TECHNICAL NOTE No. 027-2006

Model: SXV-RXV 450/550

Subject: New mappings and starter gear ratios

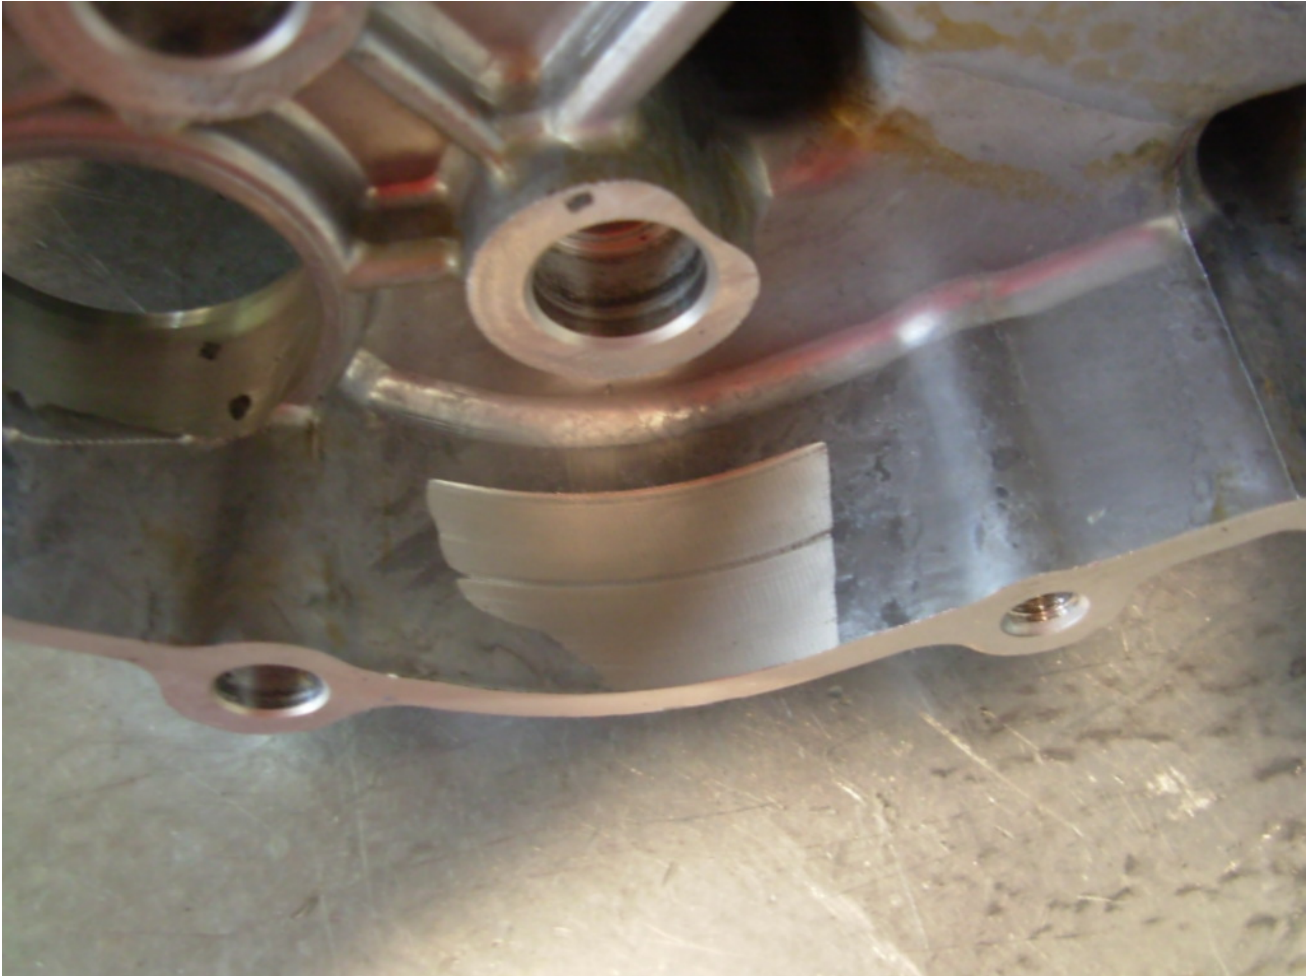
We would like to inform you that the new mappings with new starter motor timing will be available with Axone version 5.1.1.

The user will be allowed to continuously operate starter motor for a max. of 6 seconds. After this time period, control unit will disable vehicle starting for 10 seconds.
